**C-18 McCullough Avenue Sewer Replacement Project**  
**Solicitation Number: CO-00390-SM**  
**Job No.: 17-4555**

**ADDENDUM 2**  
**December 17, 2020**

SCALE: AS SHOWN  
SHEET NO. **C-10**  
28 OF 74

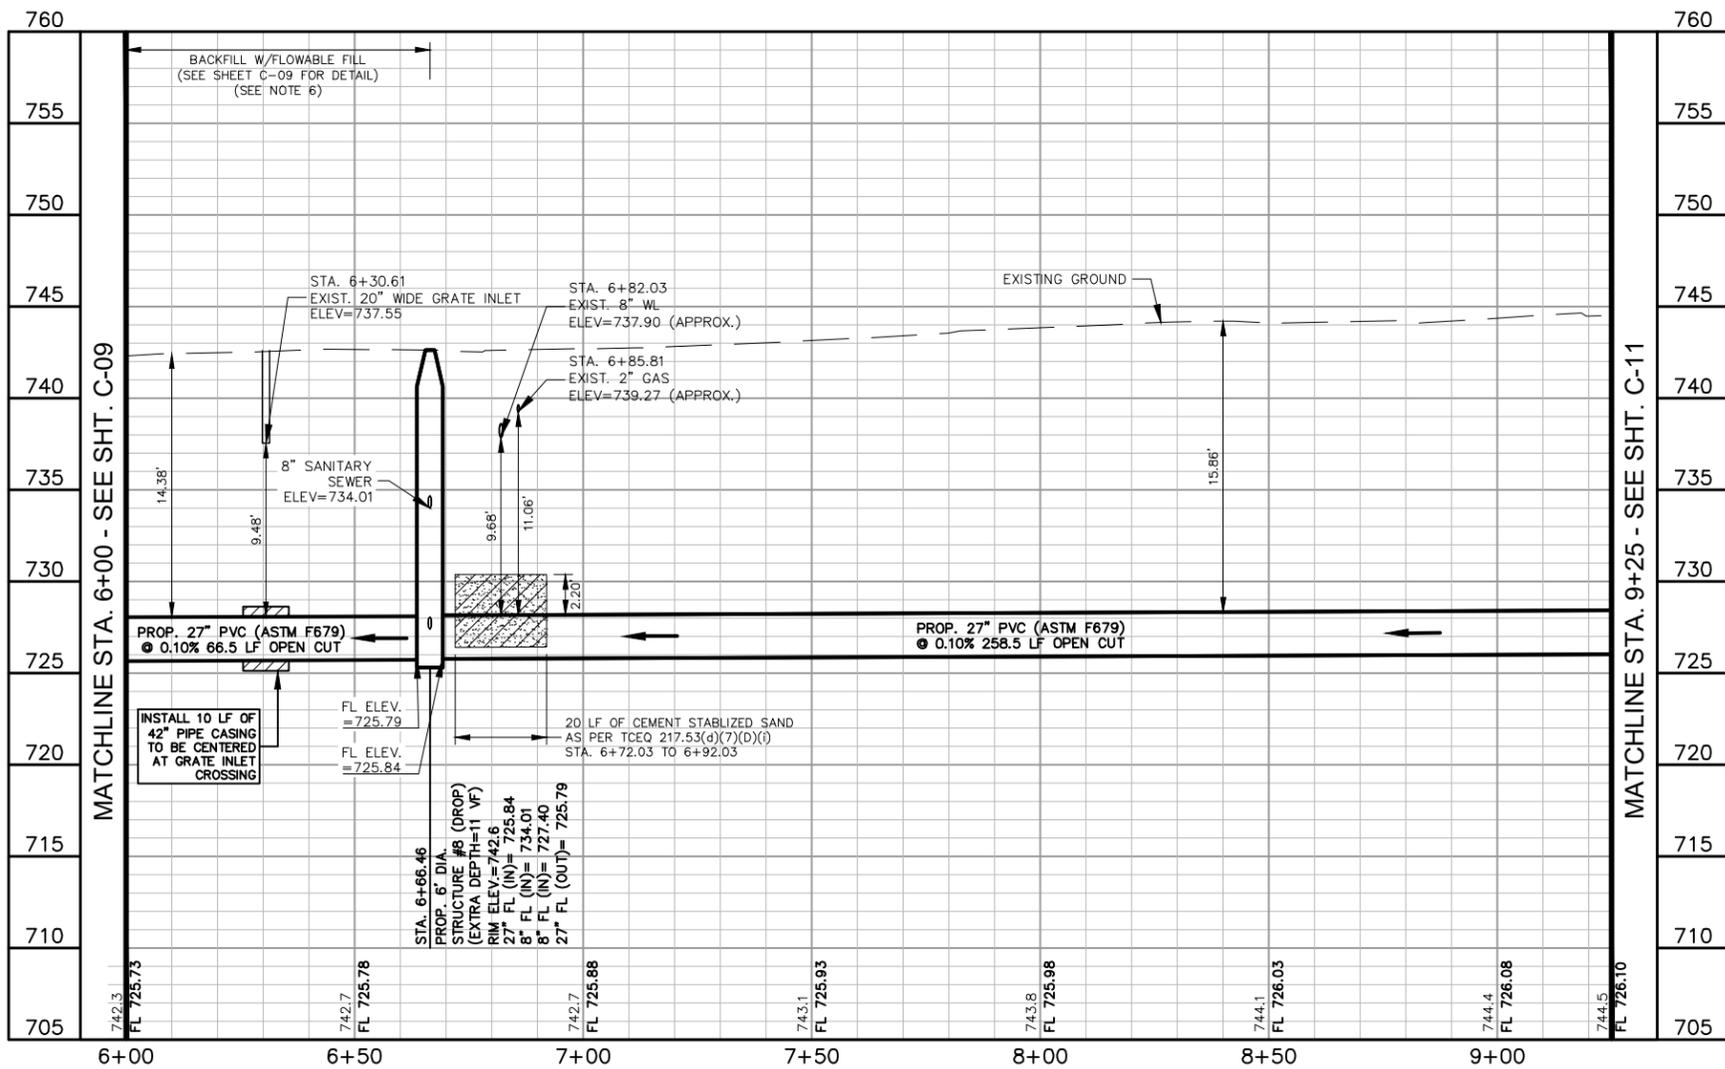
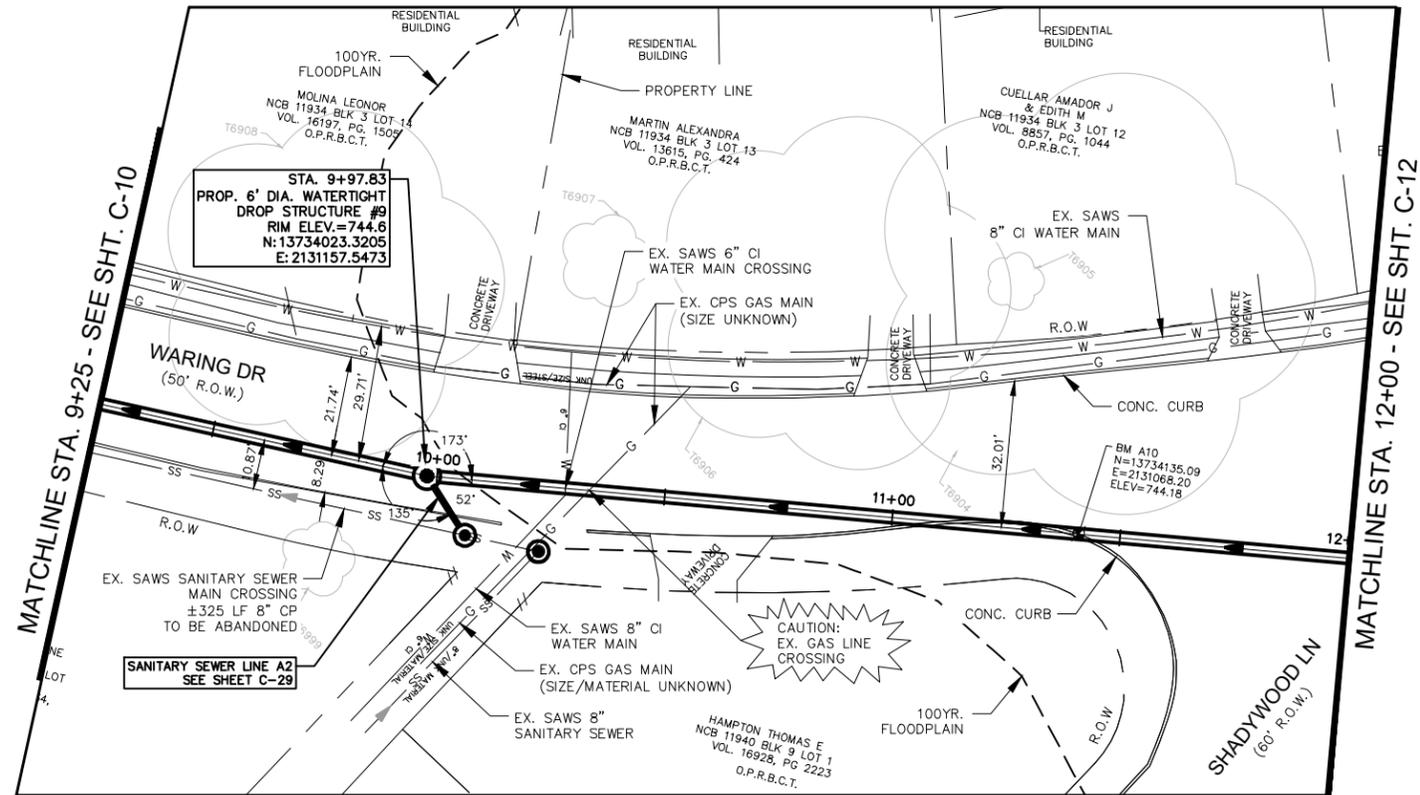
3. Plan Sheet C-10: Line item “858 concrete encasement, cradles, saddles” is removed in its entirety. Concrete encasement, saddles, cradles and collars shall be subsidiary to pipe installed. No separate pay item. Cement Stabilized Sand shall be in compliance with TCEQ Code 217.53(d)(7)(D)(i) and shall be subsidiary to pipe installed. No separate pay item for cement stabilized sand.

SHEET NO. C-11  
29 OF 74

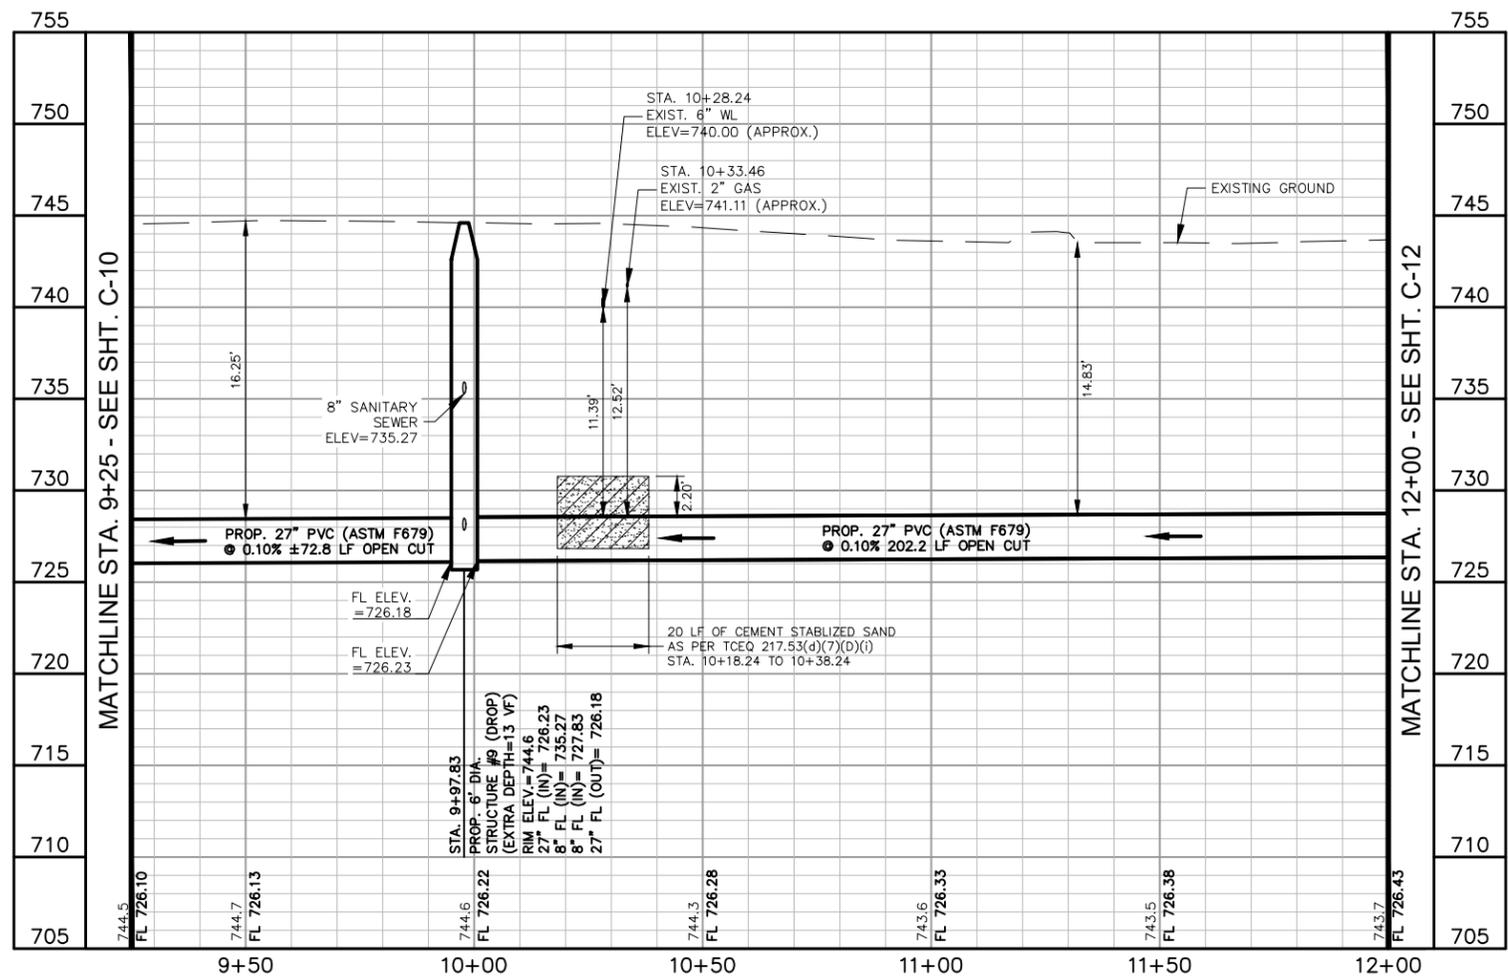
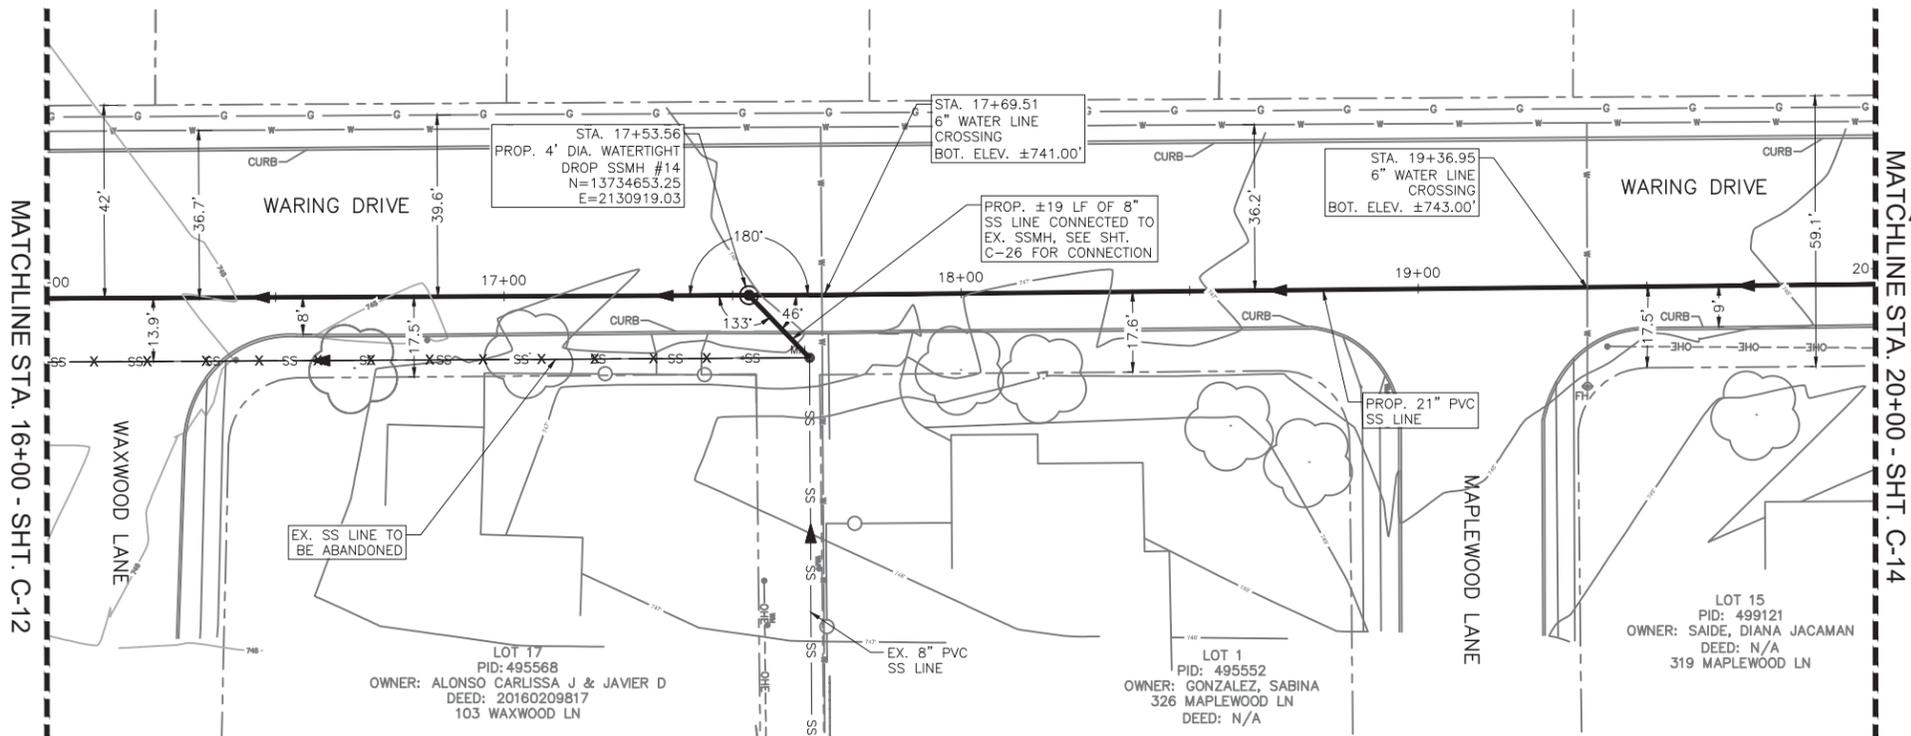
4. Plan Sheet C-11: Line item “858 concrete encasement, cradles, saddles” is removed in its entirety. Concrete encasement, saddles, cradles and collars shall be subsidiary to pipe installed. No separate pay item. Cement Stabilized Sand shall be in compliance with TCEQ Code 217.53(d)(7)(D)(i) and shall be subsidiary to pipe installed. No separate pay item for cement stabilized sand.

SHEET NO. **C-13**  
 31 OF 74

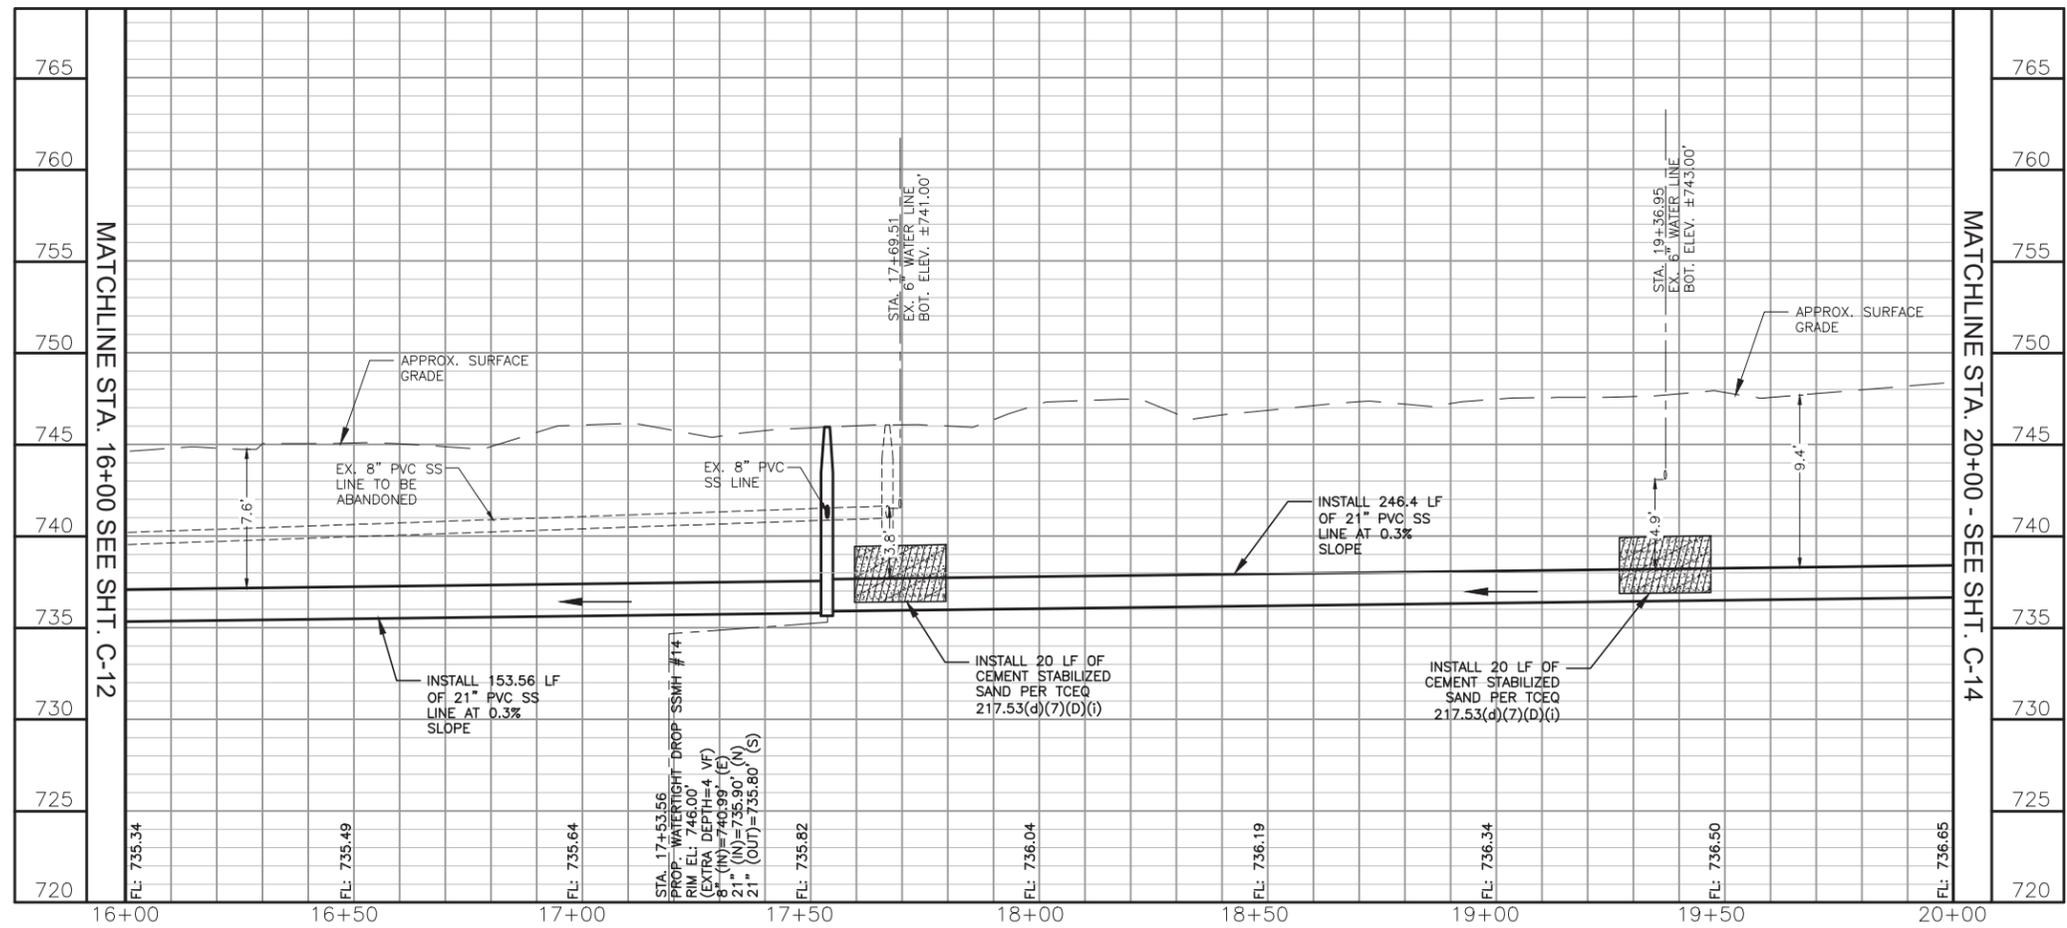
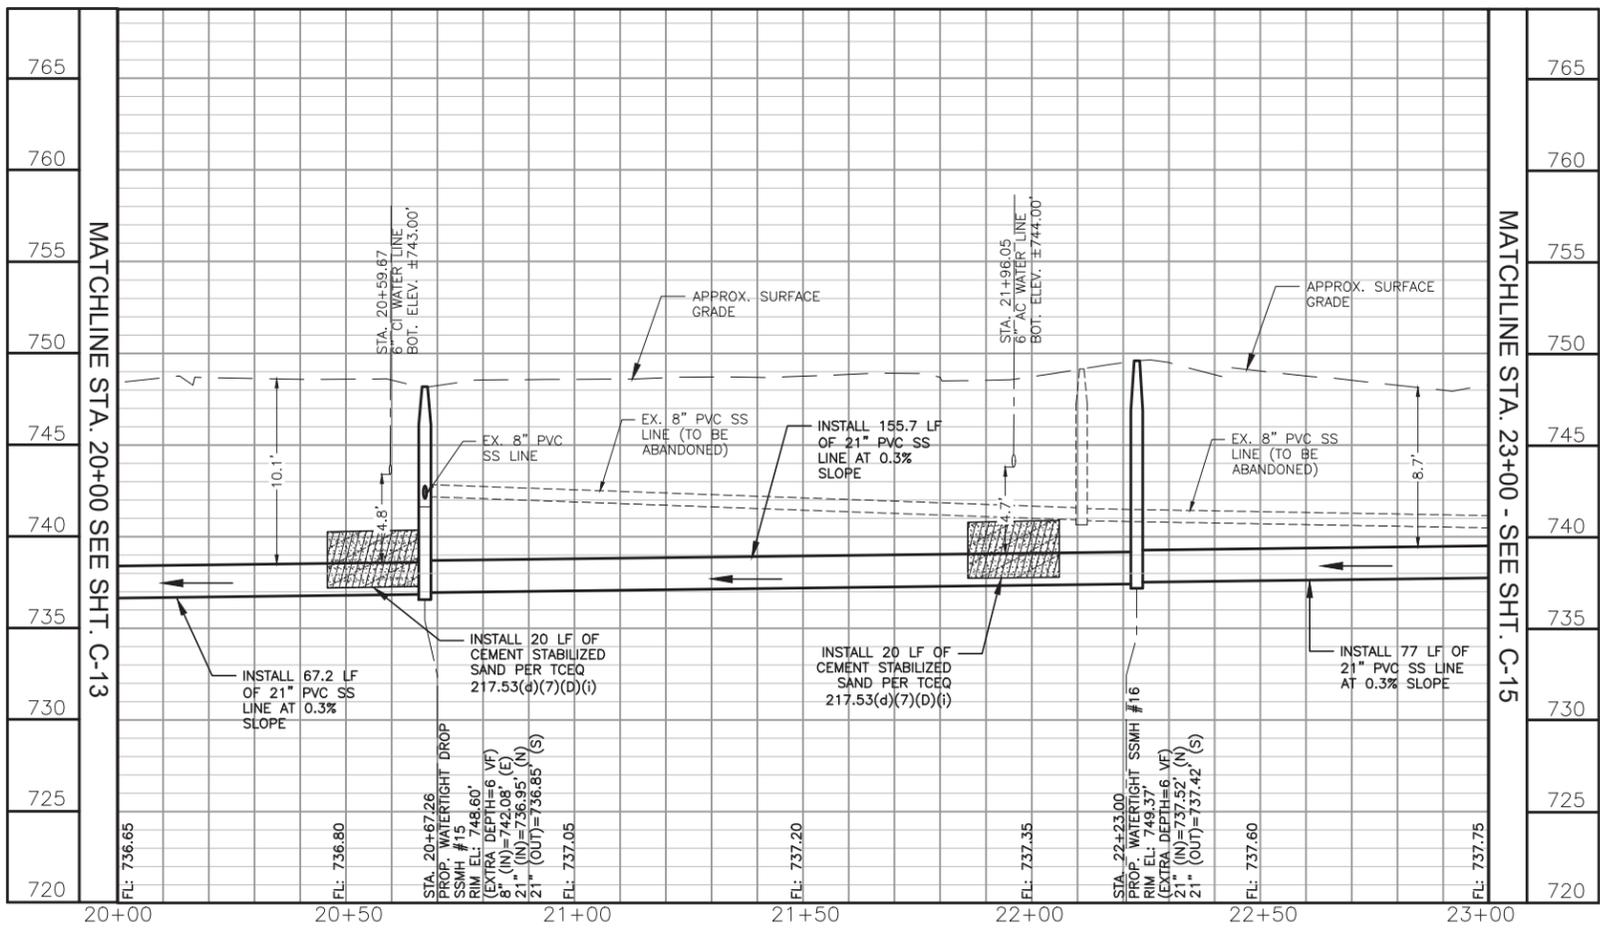
6. Plan Sheet C-13: Line item “858 concrete encasement, cradles, saddles” is removed in its entirety. Concrete encasement, saddles, cradles and collars shall be subsidiary to pipe installed. No separate pay item. Cement Stabilized Sand shall be in compliance with TCEQ Code 217.53(d)(7)(D)(i) and shall be subsidiary to pipe installed. No separate pay item for cement stabilized sand.
